Amendments to the Drawings

10/685,872 MEG-02-015

FIG 3a

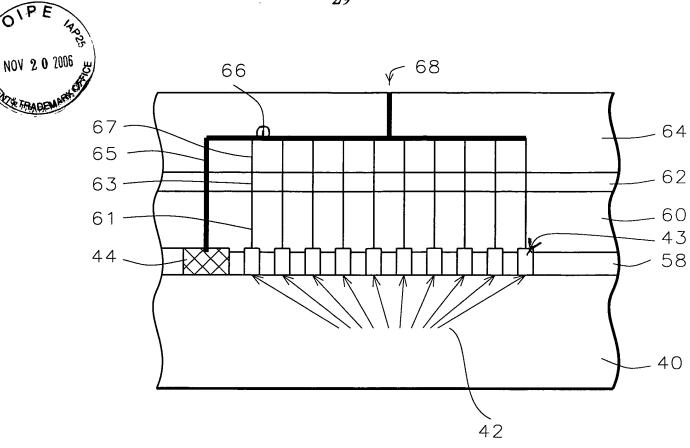
Figs. 3a, 3b, and 3c have been amended to include an arrow point on the reference line 43. Fig. 3a has been amended to extend reference line 66. Fig. 3b has been amended to extend reference lines 66 and 65. Fig. 3c has also been amended to identify passivation layer 62, as in Figs. 3a and 3b. Fig. 3c has also been amended to show an opening to the aluminum metal 61' as described in the first full paragraph on page 24, and in the paragraph bridging pages 15 and 16, and as shown in Figs. 6c and 6d. A missing line between layers 58 and 60 has been added.

FIG. 4α

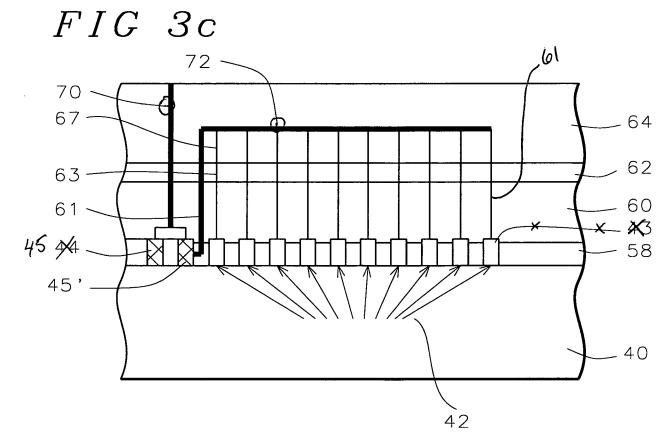
Fig. 4a has been amended to remove the reference number 43. 43 is a power or ground node. Fig. 4a addresses signals, as described in the paragraph bridging pages 24 and 25, not power or ground voltages. Fig. 4a has also been amended to replace 44 with 45, as shown in Fig. 4b. A reference number 61 has also been added to the right side of the figure. The reference lines 70 and 72 have been extended.

FIG 4b

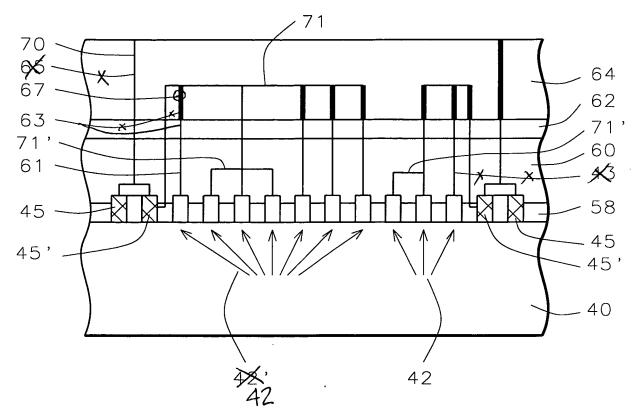
Fig. 4b has been amended to correct the positioning of the line for reference numbers 63 and 67, as shown in Fig. 4c. The prime has been deleted from 42 to be consistent with Figs. 4a and 4c. 43 has been removed, as discussed above. Duplicate reference number 65 has been removed.

FIG. 4c

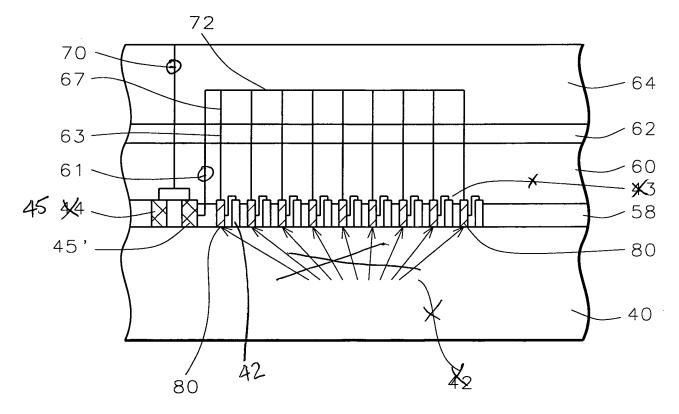
Fig. 4c has been amended to replace 44 with 45, as shown in Fig. 4b. Fig. 4c has also been amended to correct 42 to point to one of the circuits next to an intra-chip driver or receiver 80. 43 has been removed, as discussed above. Reference lines 61 and 70 have been extended.

FIG 4d

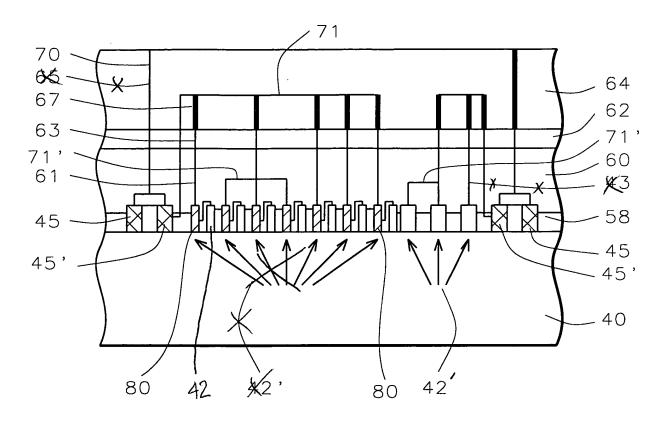
Fig. 4d been amended to correct 42 to point to one of the circuits next to an intra-chip driver or receiver 80 and to show 42' on the right side of the figure. 43 has been removed, as discussed above. Duplicate reference number 65 has been removed.

FIG. 5α

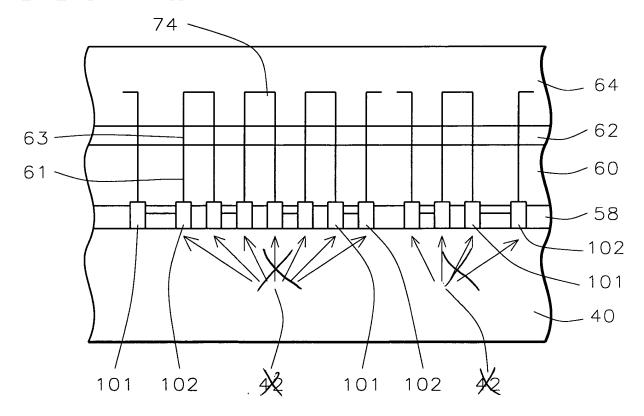
Fig. 5a has been amended to remove reference number 42 which is not part of this figure. This figure shows driver/receivers, transceivers, or repeater devices 101 and 102, as described in the paragraph bridging pages 29 and 30.

FIG 5b

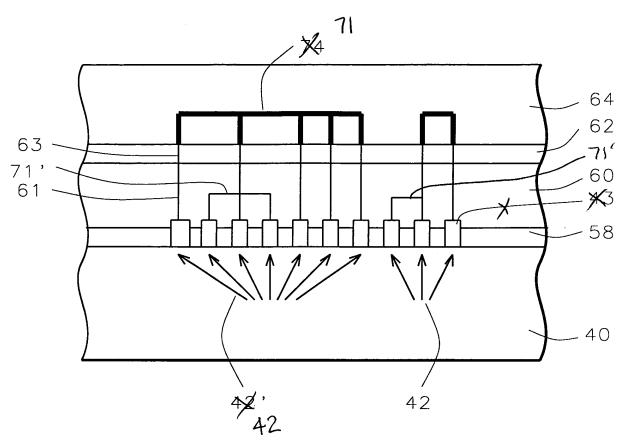
Fig. 5b has been amended to refer to the lines in layer 64 as 71 and the lines in layer 60 as 71', as described in the last paragraph on page 30. A reference line 71' has been added to the right side of the figure. Fig. 5b has also been amended to replace 42' with 42. 43 has been removed as discussed above.

FIG. 5c

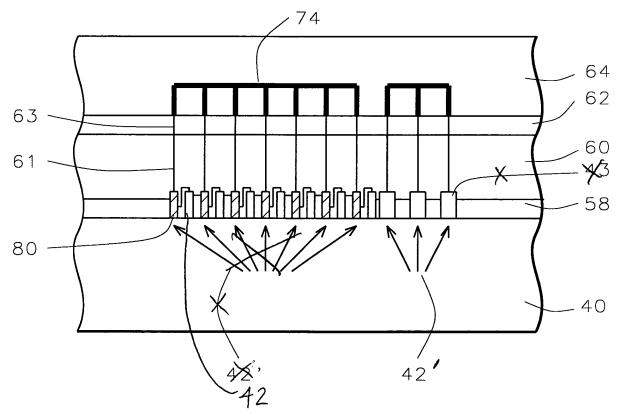
Fig. 5c has been amended to show 42' on the right side of the figure and to correct 42 to point to one of the circuits next to an intra-chip driver or receiver 80. 43 has been removed as discussed above.

FIG 5d

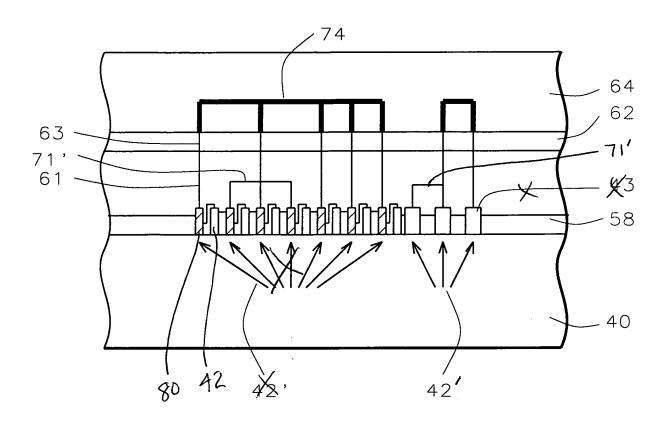
Fig. 5d has been amended to show 42' on the right side of the figure and to correct 42 to

point to one of the circuits next to an intra-chip driver or receiver 80, as shown in amended Figs.

4c and 5c. A reference number 71' has been added to the right side of the figure, as in Fig. 4d.

43 has been removed as discussed above.
